# City of Kitchener - Comment Form

**Project Address:** 83-87 Weber Street East

**Application Type:** OPA/ZBA

**Date:** July 24, 2023  
**To:** Craig Dumart  
**From:** Jason Brûlé  
**Subject:** Zoning By-law Amendment and Official Plan Amendment Application  
Brigade Holdings Corporation  
83-87 Weber Street East, Kitchener  
ZBA 23/022/W/CD  
OPA 23/012/W/CD

**Wind Study - Pedestrian Level Wind – Preliminary Impact Assessment. Boundary Layer Wind Tunnel Laboratory report**

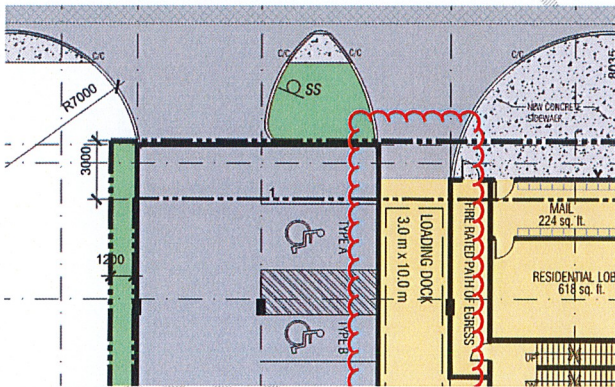
A further quantitative wind study coupled with a detailed wind tunnel analysis will be required as part of the full site plan application package.

A revised design proposal that addresses the wind impacts outlined in the submitted wind study should be developed.
